Webster Univ. Interdisciplinary Science Bldg.

Coiling Door Locator Schedule

SUBMITTAL IDENTIFICATION SHEET

083333-002
CONTRACTOR / CM SUBMITTAL NO.

SECTION @ EGRESS DOOR (TYP.)

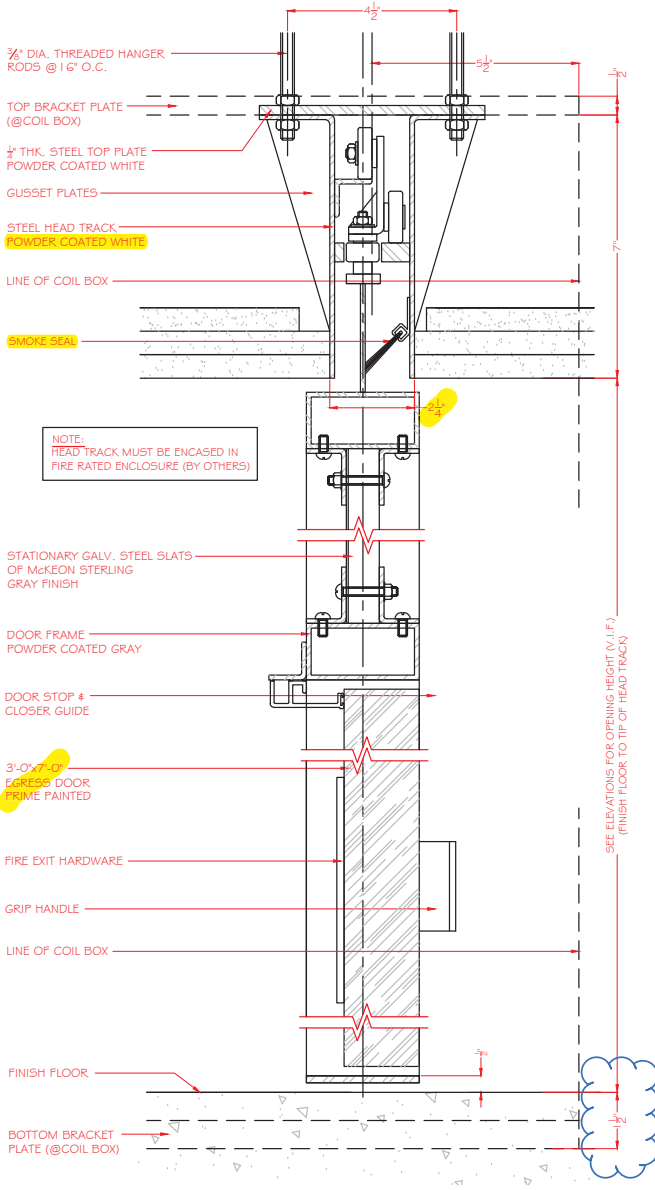
NOTE: McKEON WILL PROVIDE ⅜" DIA. FULLY THREADED RODS 12" LONG

Not long enough, GC to coordinate

GC to coordinate pit locations

SECTION @ CURTAIN (TYP.)

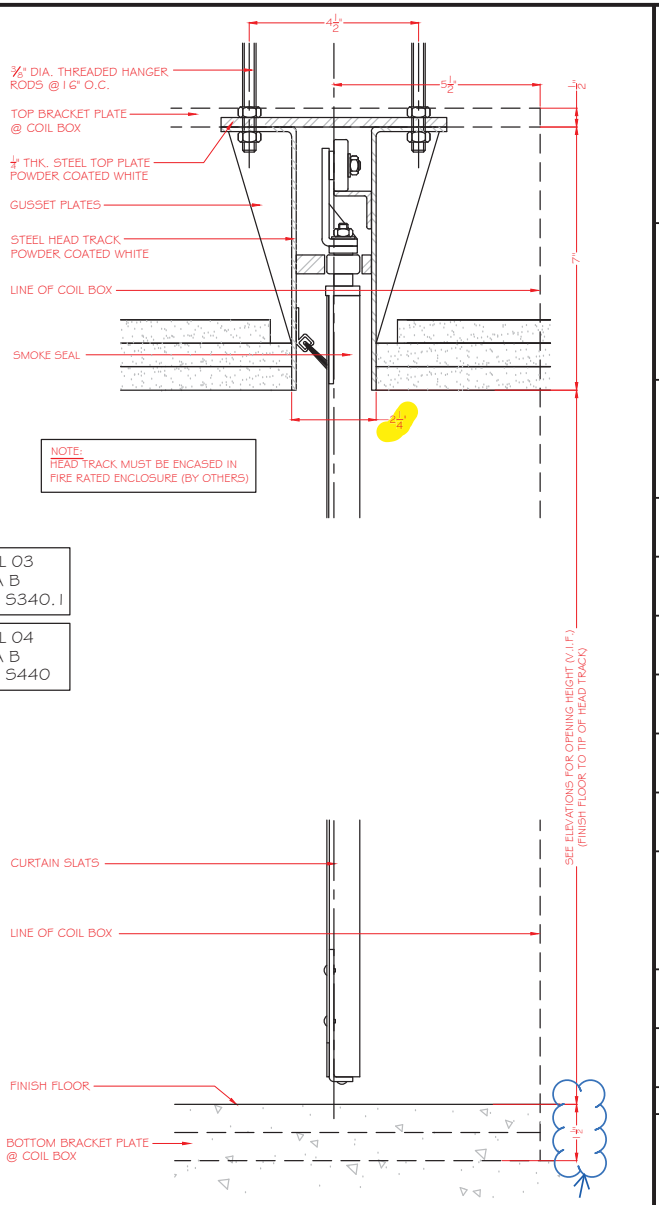
GC to coordinate pit locations

COIL BOX PIT (BY OTHERS) (TYP.)

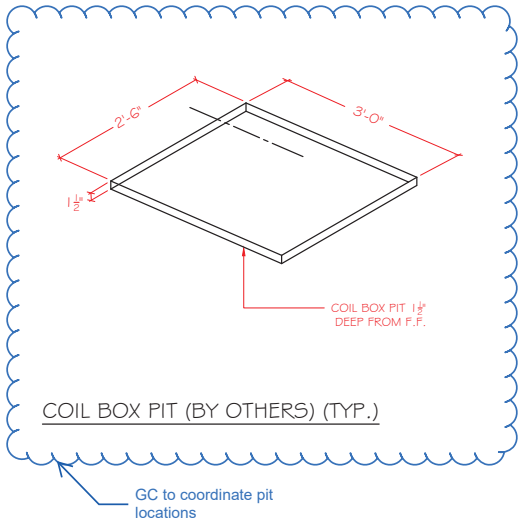
GC to coordinate pit locations
